Title - Sujet Equipment Maintenance Building	
Solicitation No. - N° de l'invitation EZ899-181343/A	Amendment No. - N° modif. 003
Client Reference No. - N° de référence du client	Date 2017-11-21
GETS Reference No. - N° de référence de SEAG PW-\$PWY-022-8224	
File No. - N° de dossier PWY-7-40239 (022)	CCC No./N° CCC - FMS No./N° VME
Solicitation Closes - L'invitation prend fin at - à 02:00 PM on - le 2017-11-29	Time Zone Fuseau horaire Pacific Standard Time PST
F.O.B. - F.A.B. Plant-Usine: <input type="checkbox"/> Destination: <input checked="" type="checkbox"/> Other-Autre: <input type="checkbox"/>	
Address Enquiries to: - Adresser toutes questions à: Arthur (PWY), Carolyn	Buyer Id - Id de l'acheteur pwy022
Telephone No. - N° de téléphone (604) 364-2752 ()	FAX No. - N° de FAX (604) 775-6633
Destination - of Goods, Services, and Construction: Destination - des biens, services et construction: TC - Port Hardy Airport - Port Hardy, BC

This amendment 003 is raised to:

- 1) Incorporate Addendum No. 1

PROJECT: PORT HARDY AIRPORT EQUIPMENT
MAINTENANCE BUILDING

DRAWING NO:
AE-01 - ESK-08

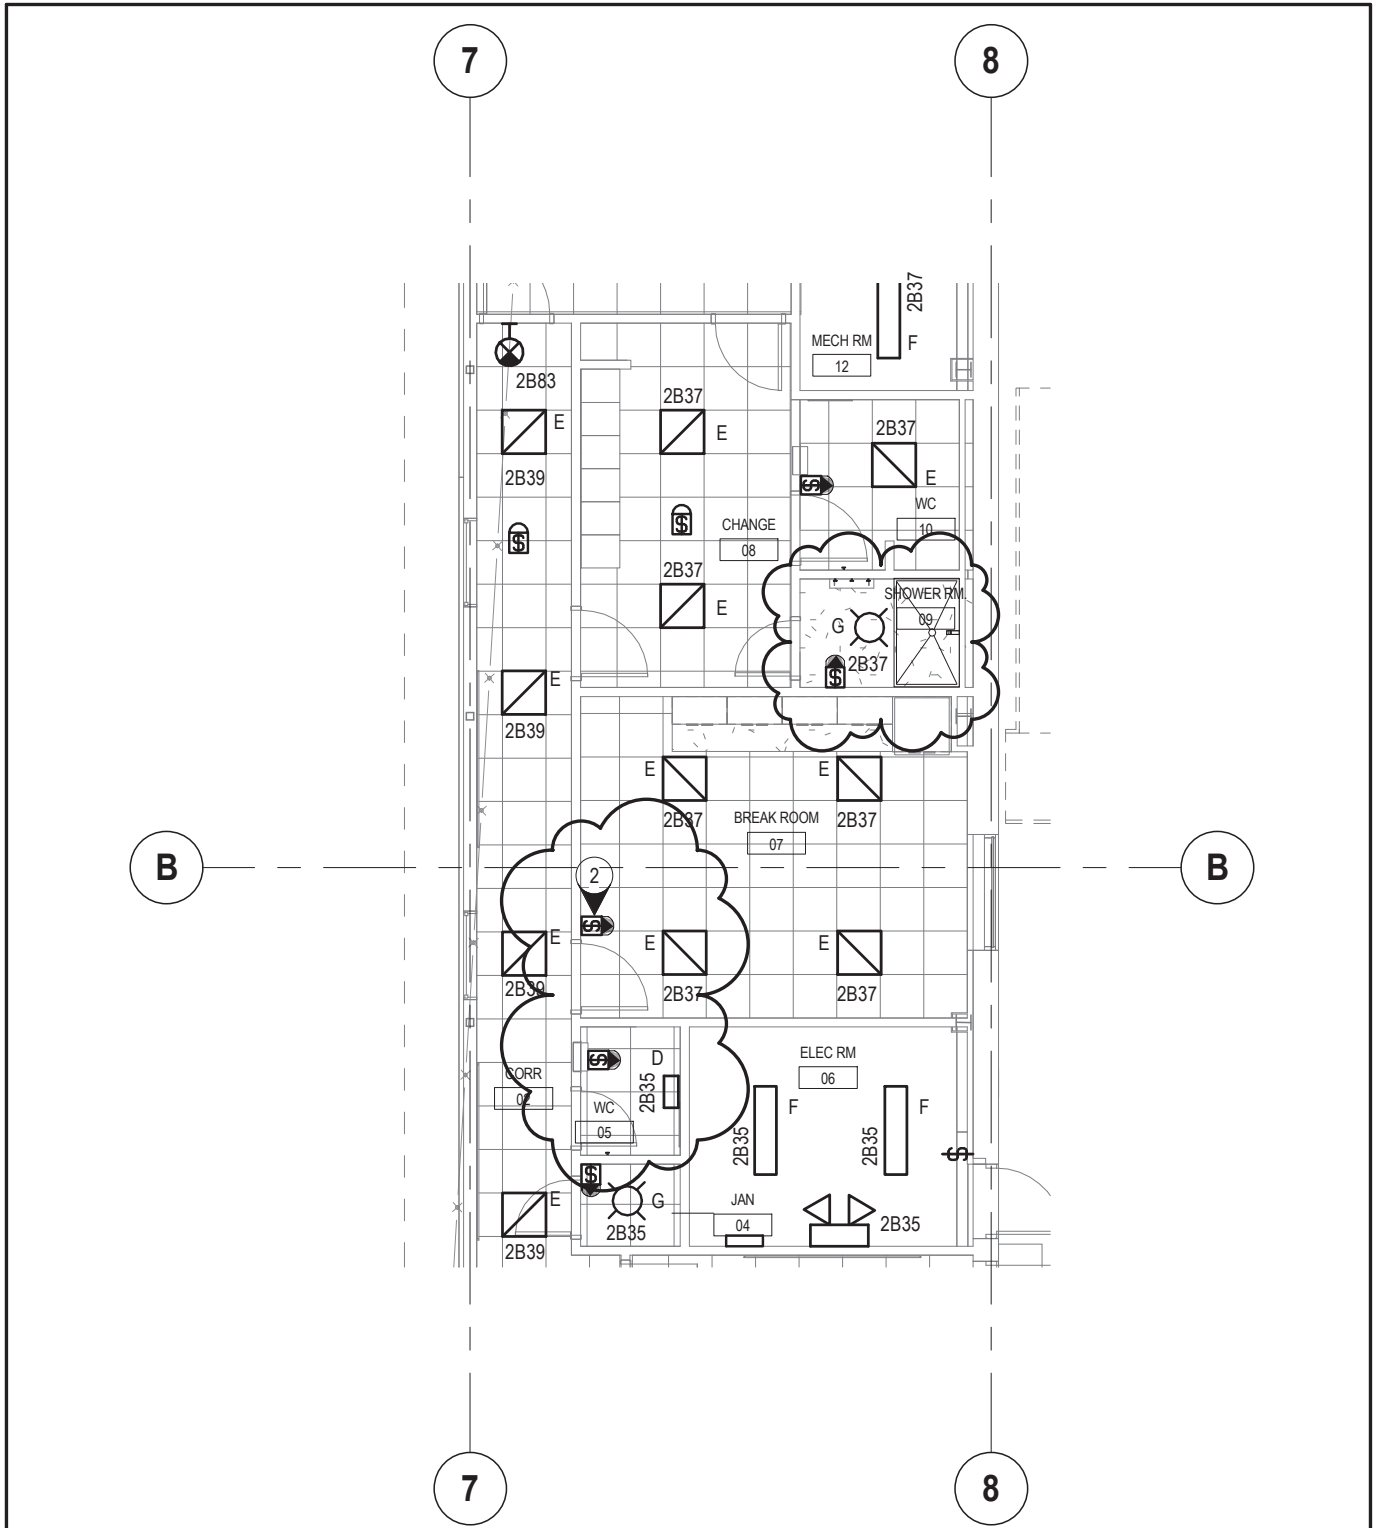
- .7 Provide a Mechanical DDC panel in the Telecom Rm c/w power and communication connections as shown, refer to electrical sketch ESK-09.
- .8 Refer to electrical sketch ESK-08 for clarification on communication cabling to main electrical room.

DRAWING NO:
AE-01 - ESK-09

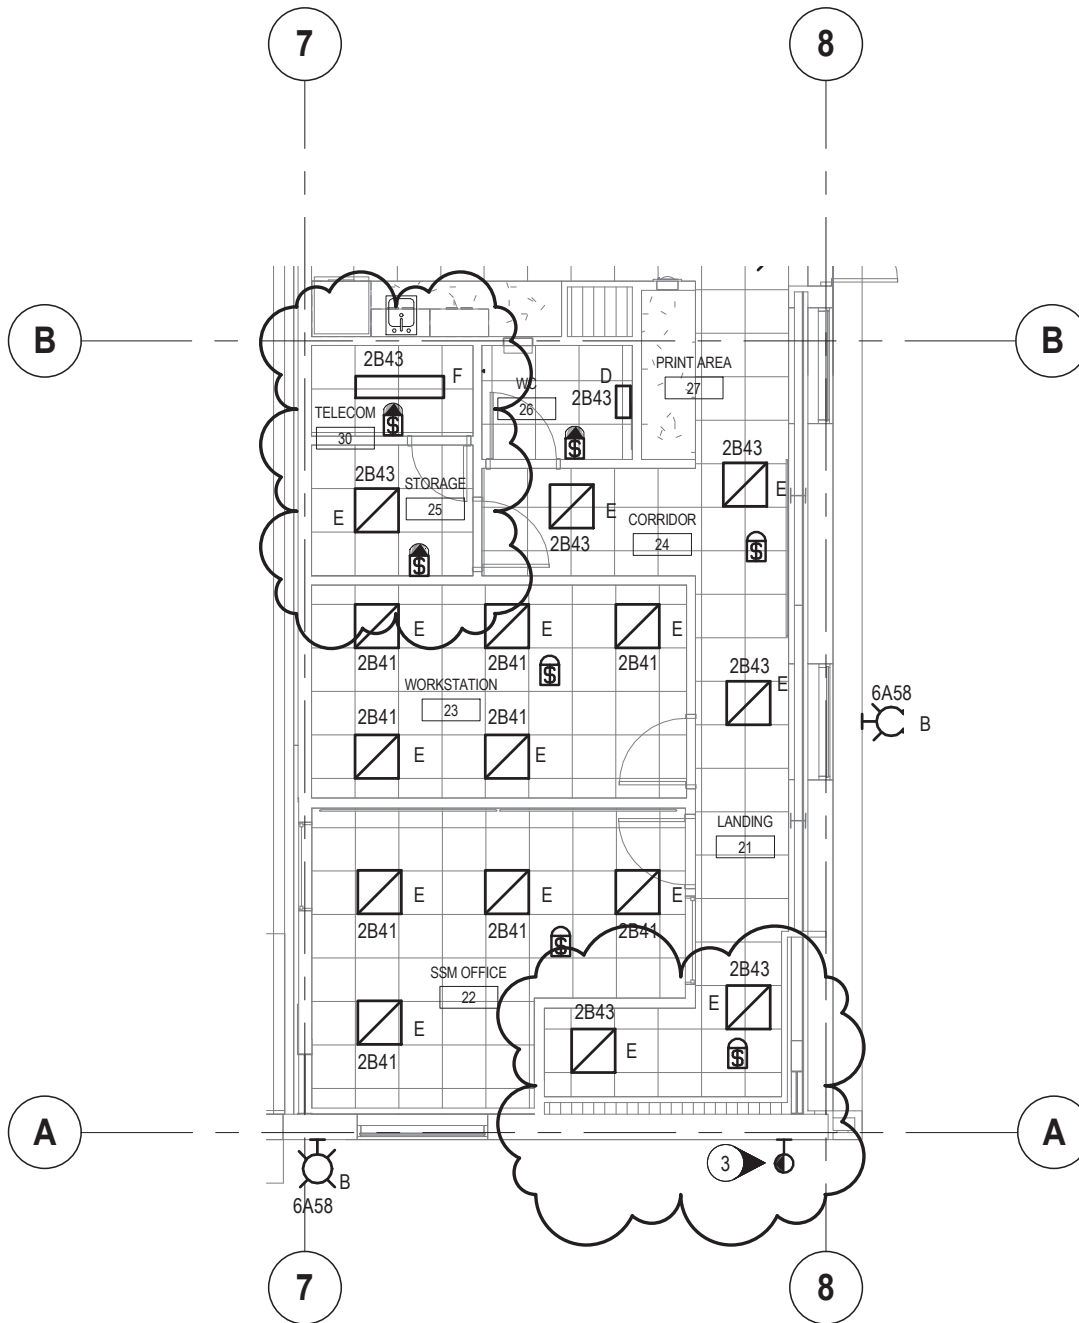
.1 Refer to electrical sketch ESK-09 and ESK-10 for floor lighting revisions;

.1 WC 05 luminaire type D

.2 Lighting control added for Shower 09, Storage 25 and Telecom 30.

.3 Added a type E fixture for stairs.

.4 Break room 07 light switch to be occupancy sensor.

.5 Photocell added for exterior lighting controls.
